LAKE HAVASU CITY, ARIZONA

ADDENDUM NO. 1

Island Path Repave

Project No: B24-PW-500412

A-A TYPICAL SECTION
SCALE 1"=1'

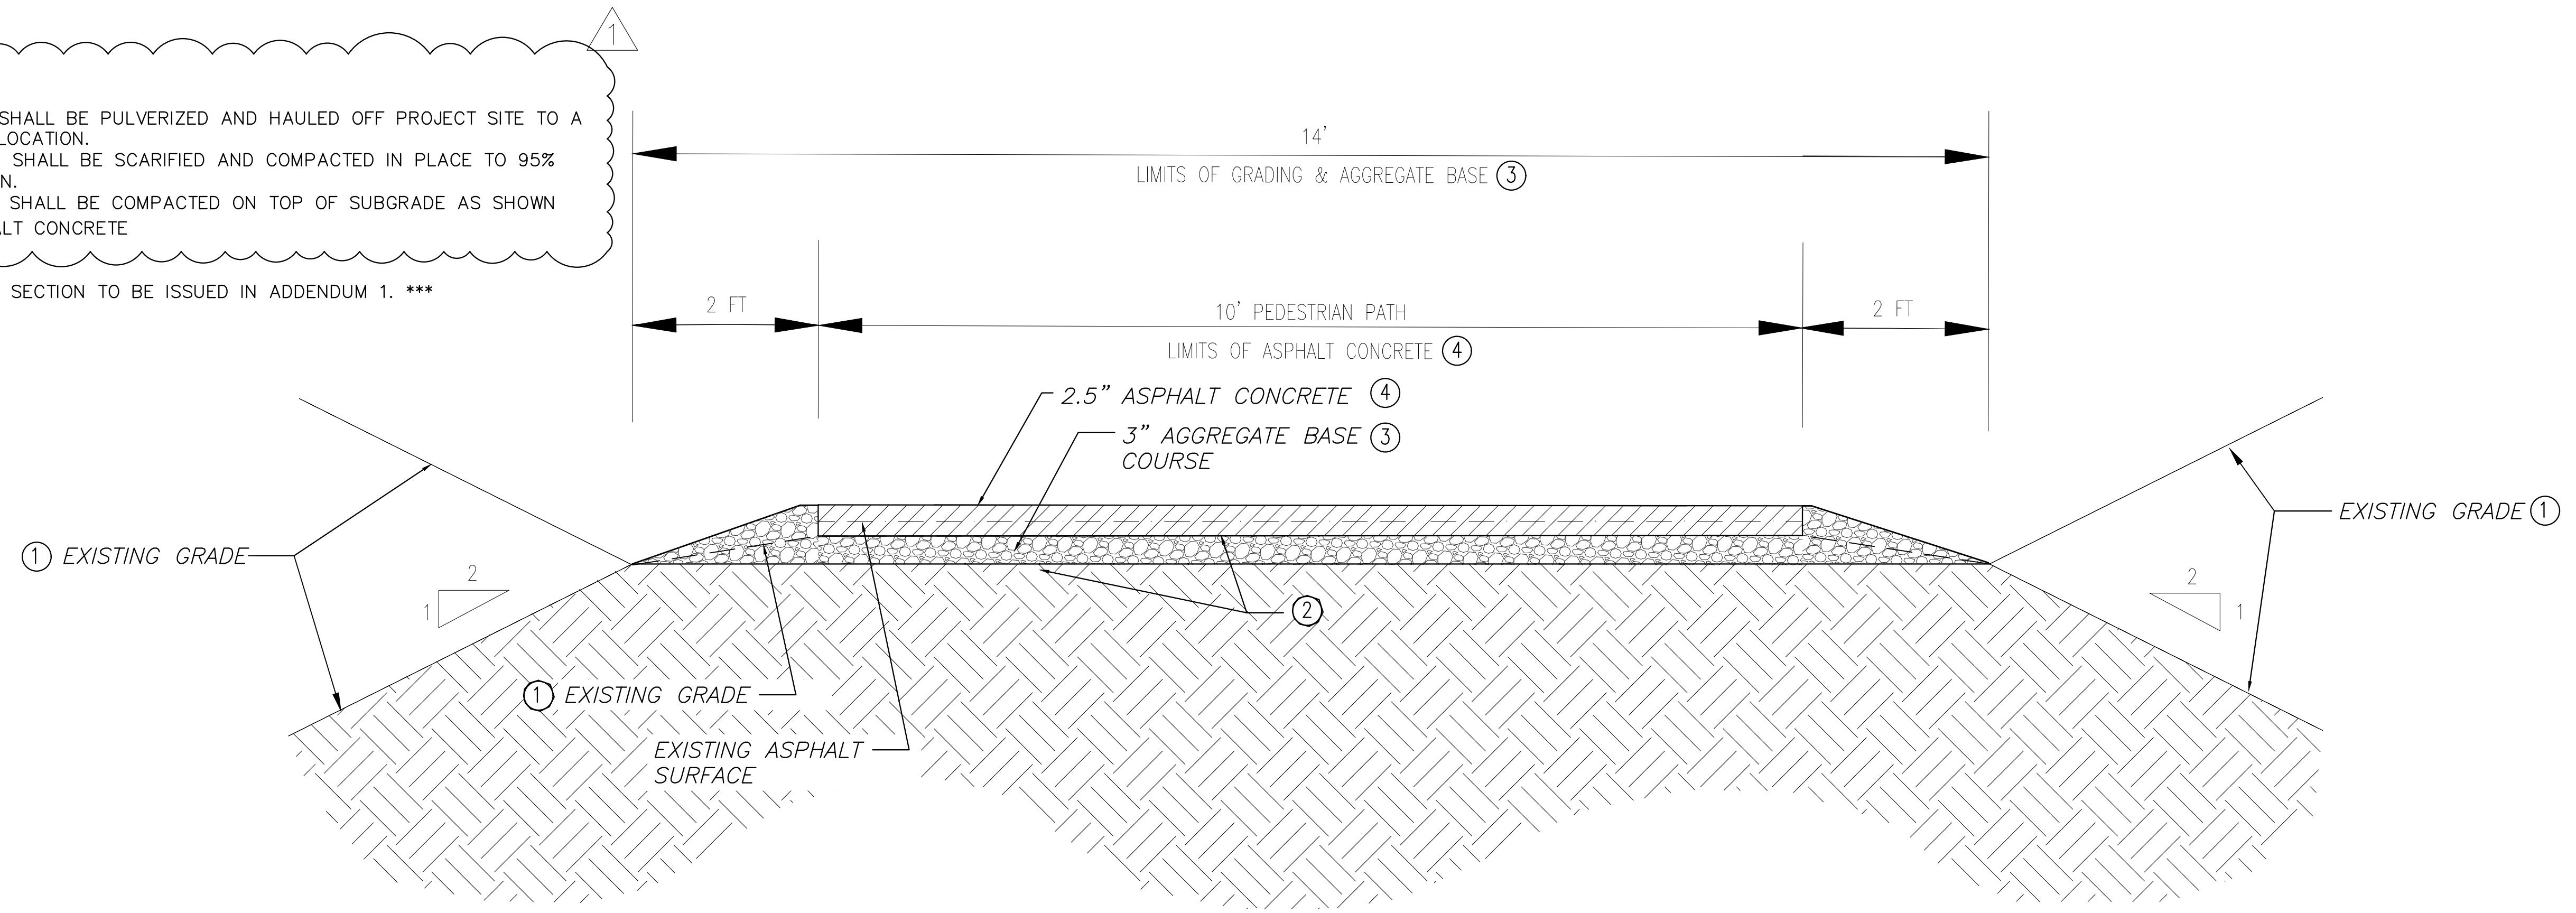
If we pulverize in place do we have to haul it off or can we use material for extra width?

Any use of the pulverized must meet graduation requirements per specification section LHC 2300-Part 2.1D for base material. Any pulverized materials not meeting gradations requirements would require a site for suitable disposal. Please refer to the revised typical section on sheet C-4 for more information.

- SECTION NOTES:**
- ① EXISTING PAVEMENT SHALL BE PULVERIZED AND HAULED OFF PROJECT SITE TO A SUITABLE DISPOSAL LOCATION.
 - ② UPPER 3" SUBGRADE SHALL BE SCARIFIED AND COMPACTED IN PLACE TO 95% RELATIVE COMPACTION.
 - ③ 3" AGGREGATE BASE SHALL BE COMPACTED ON TOP OF SUBGRADE AS SHOWN
 - ④ 2 1/2" HOT MIX ASPHALT CONCRETE

① ***REVISED TYPICAL SECTION TO BE ISSUED IN ADDENDUM 1. ***

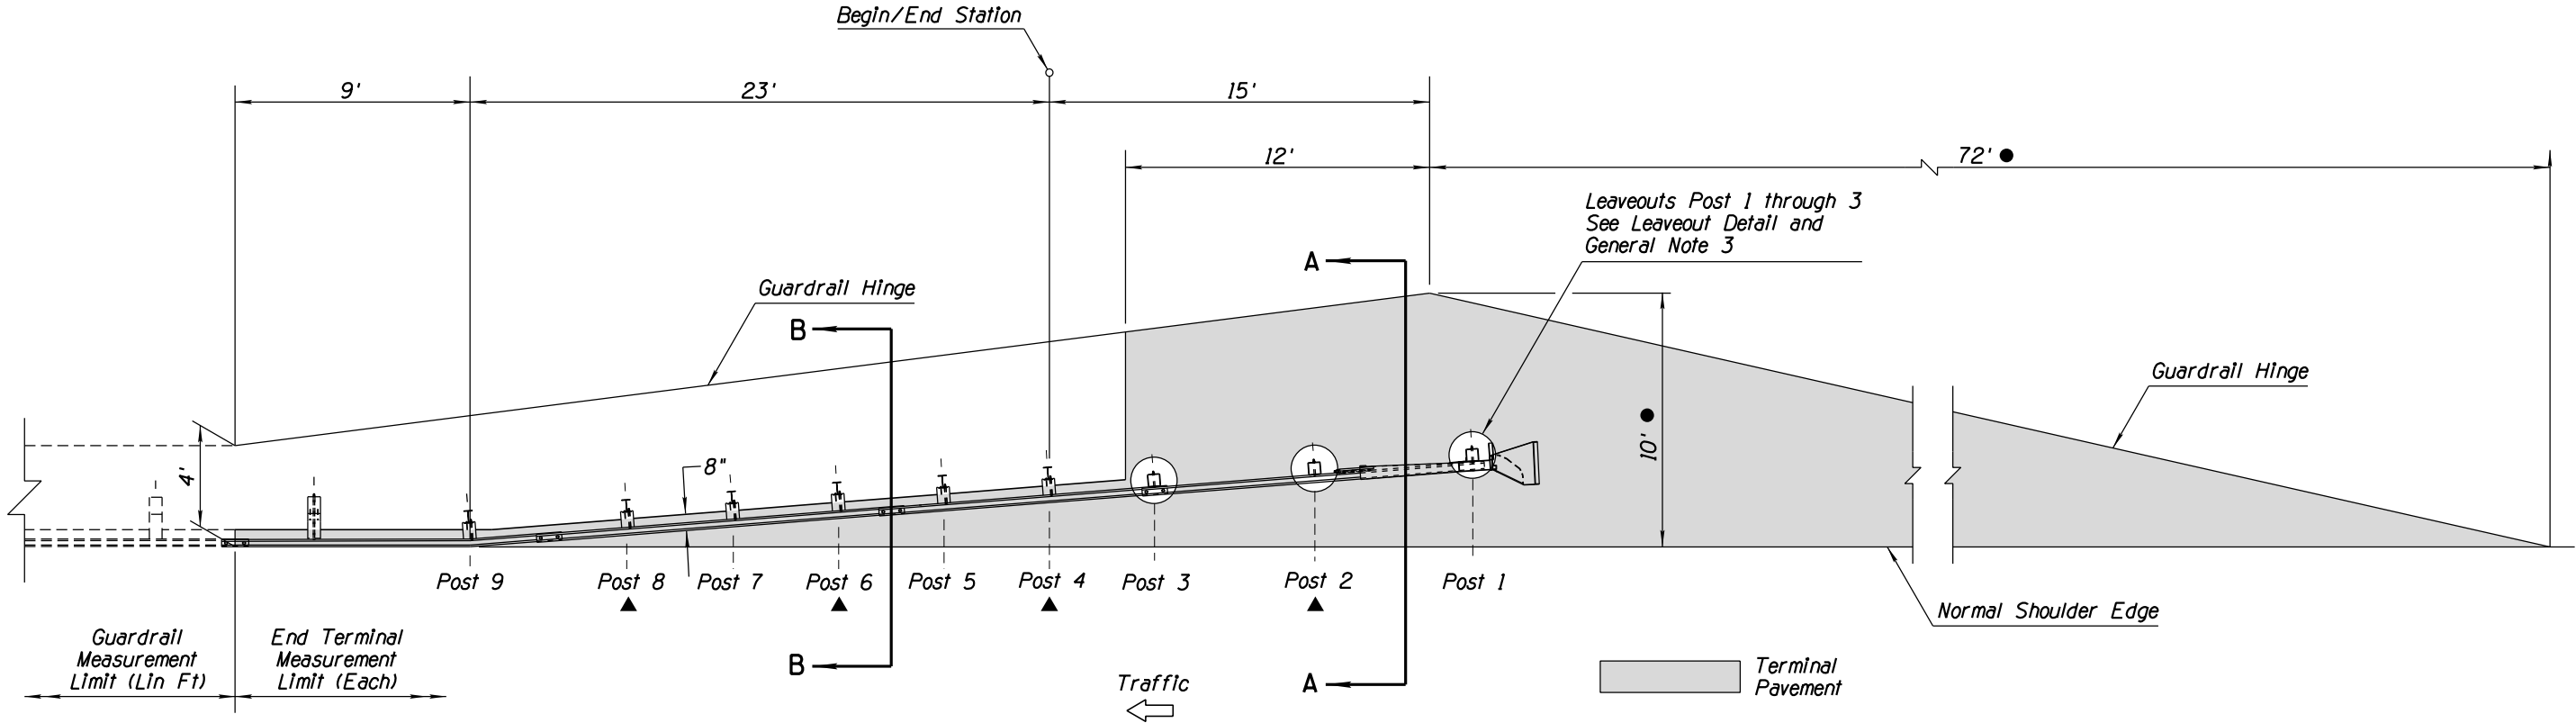
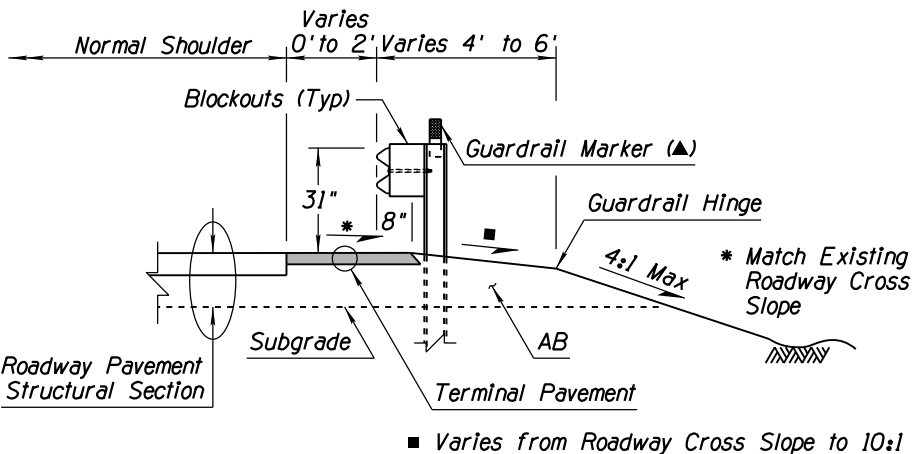
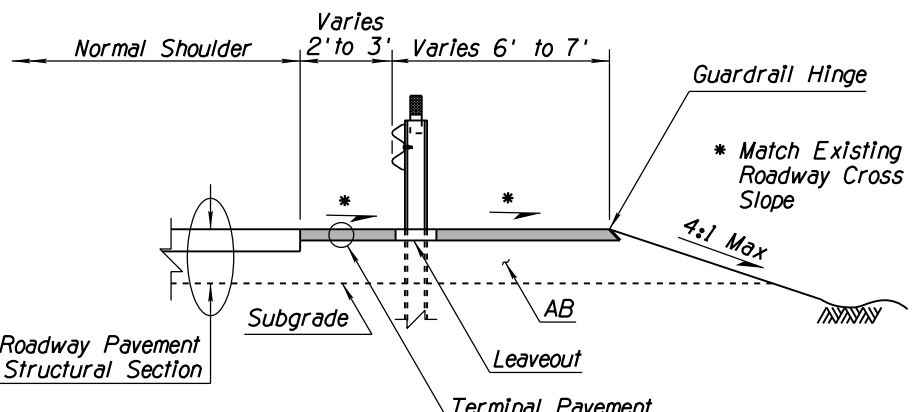
What is the guardrail end treatment? How many end treatment conditions are on the plans?

Please refer to ADOT C.10.26 for Flared End Treatment details attached to this document. Guardrail end treatment is to be constructed on 4 places on the plans.
